1. 15 Fig Tree Street, Lane Cove – St Columba's Uniting – Response to Council RFI

ptc. has been engaged by Uniting to provide traffic consultant advice in relation to Council's request for additional information for 15 Fig Tree Street, Lane Cove.

drawing title
Swept Path Analysis Porte Cochere - Ambulance

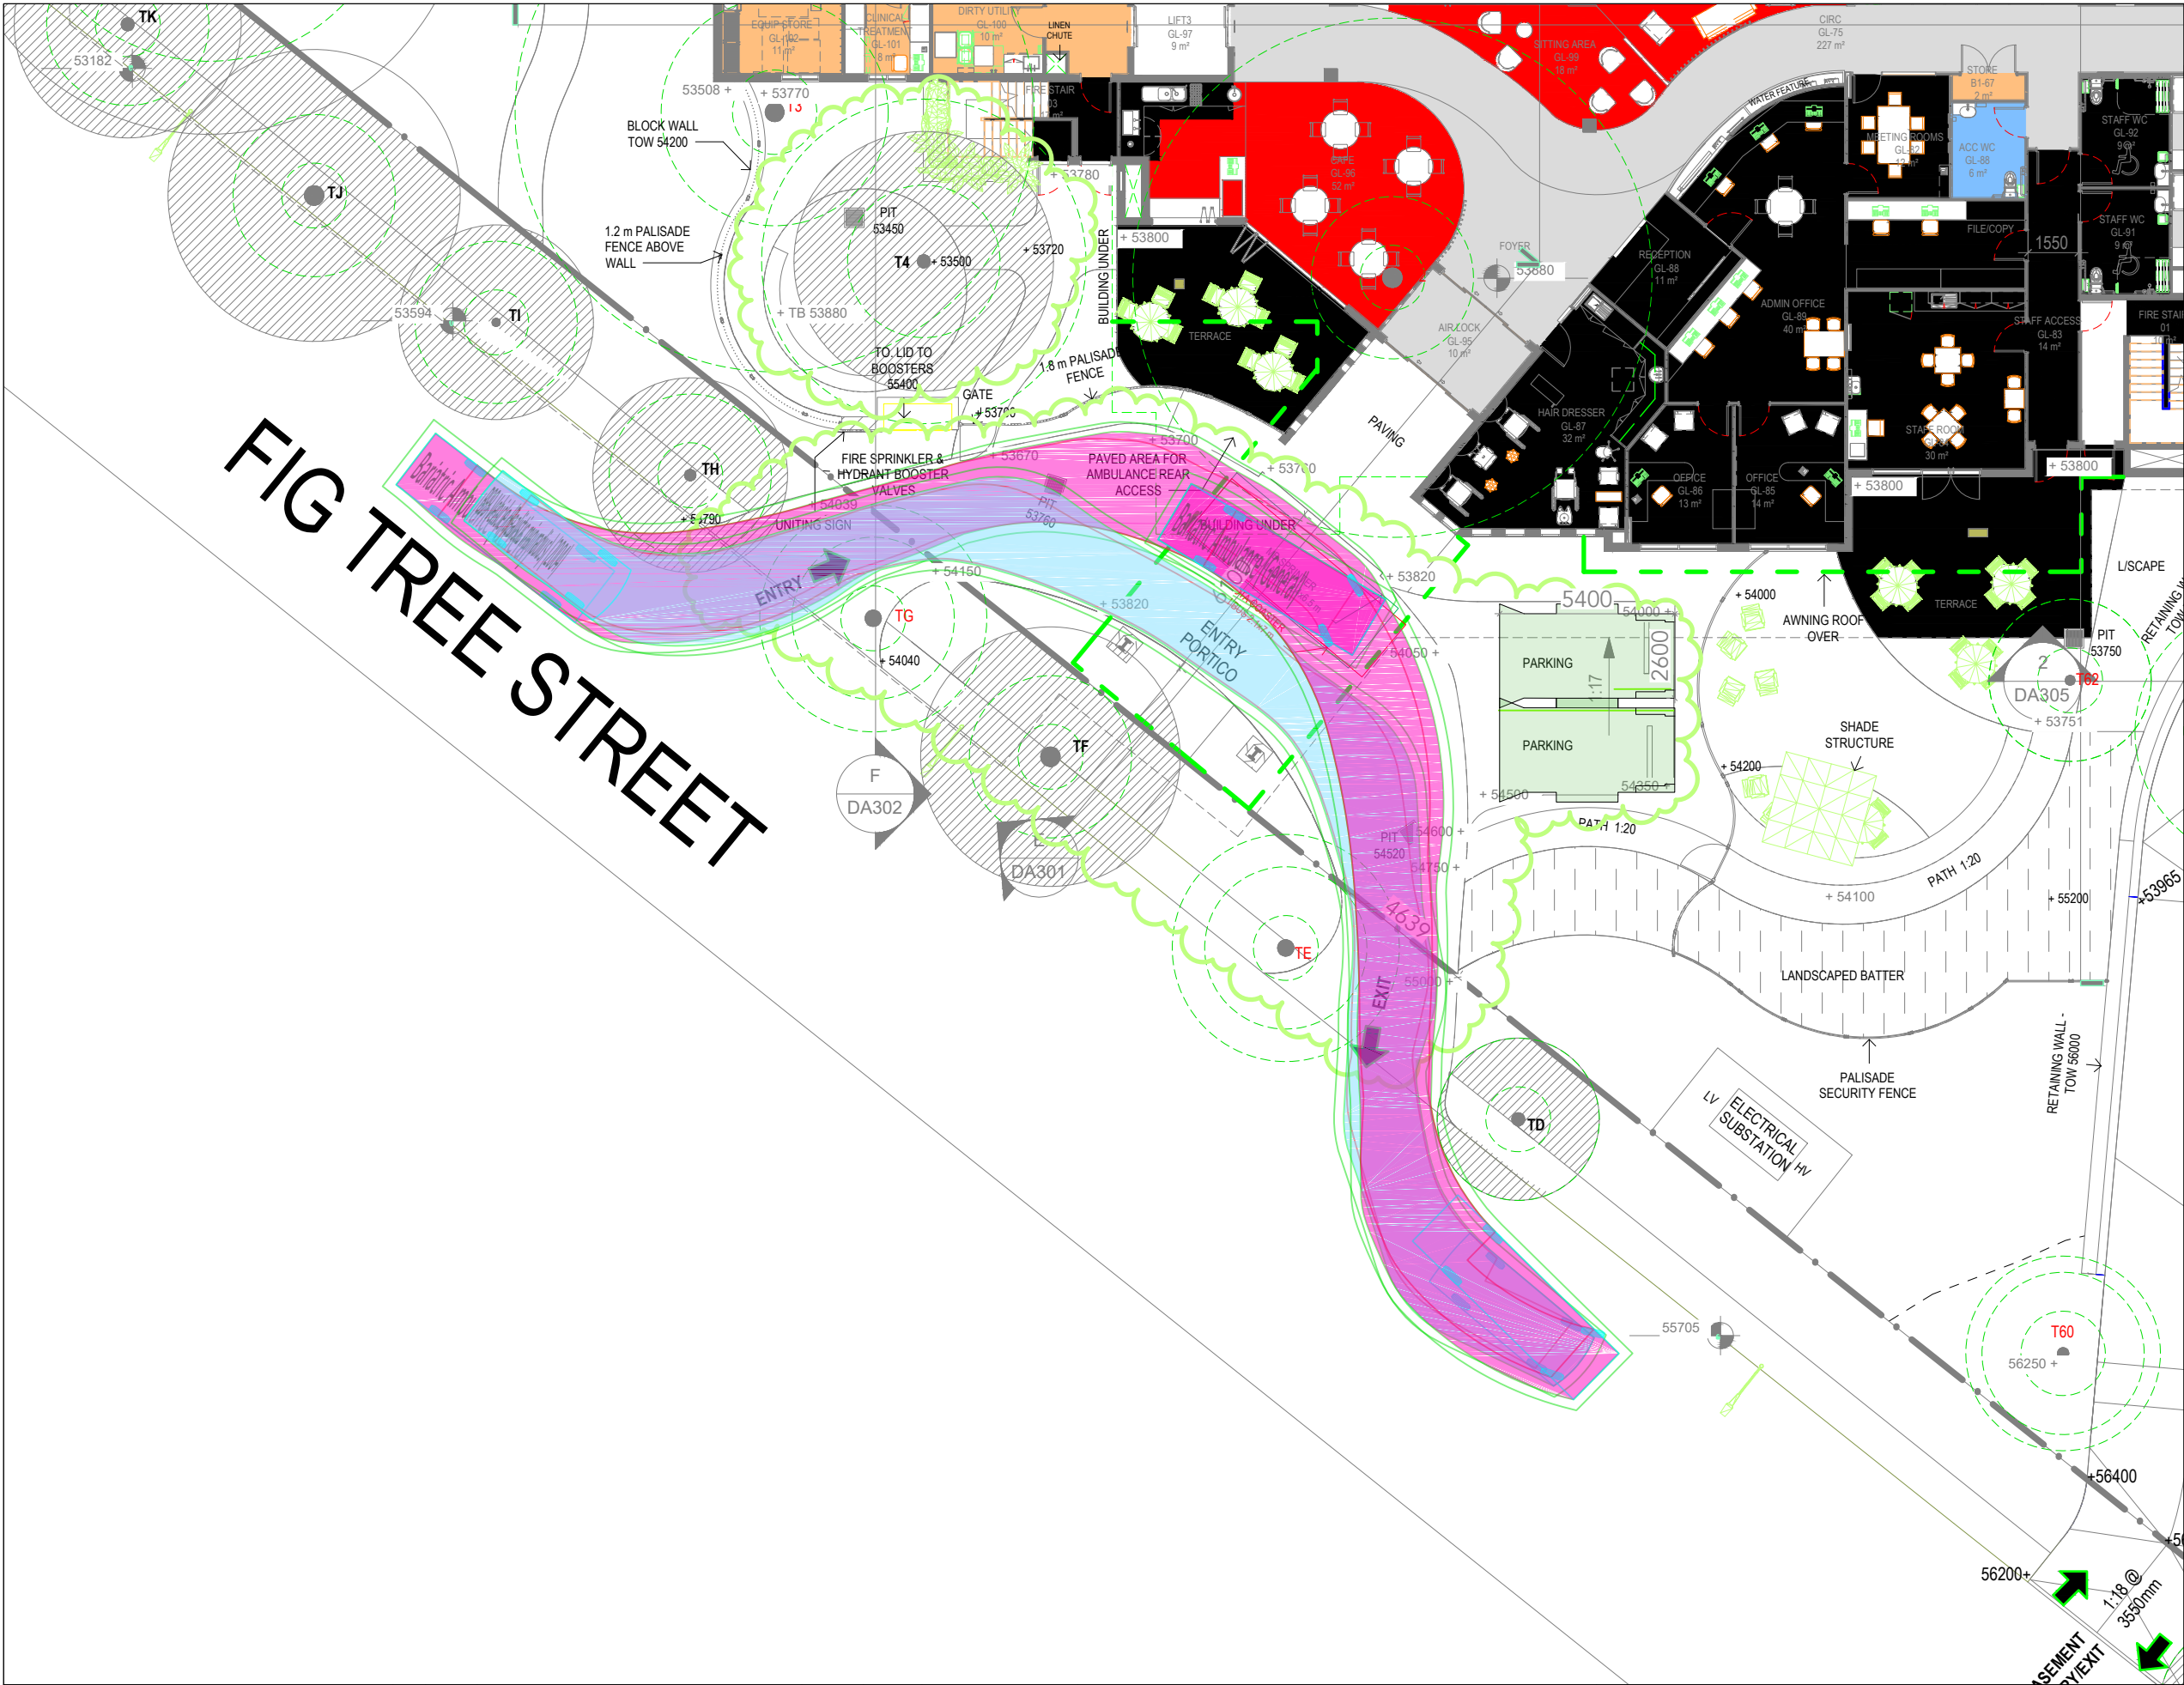
1. *The development provides access for MRVs however, the ramp and access are not designed in accordance with AS2890.2. The swept paths for a MRV indicates that there is not enough room for a MRV and B99 vehicle to pass through simultaneously. The access and ramp need to be designed and/or managed to allow for the above-mentioned vehicles to pass simultaneously.*
2. *Dimensions and swept paths for ambulance bay under porte cochere are not provided. Section 6.1 of traffic report states that the porte cochere will have 2 waiting bays, one for ambulance and the other for shuttle bus pick up. While swept paths for B99 vehicles have been provided, additional information such as dimensions of the waiting bay and swept paths for bus and ambulance in/out of existing access is to be provided.*

The design of the Porte Cochere has been amended to allow for the passing of a Bariatric Ambulance and a Toyota Coaster Minibus to access the Porte Cochere while allowing a B99 vehicle to pass. The two waiting bays have been redesigned to allow vehicles to ingress and egress the spaces while the ambulance/ minibus bay is in use.

The updated swept path analysis for the Porte Cochere is shown in Attachment 2.
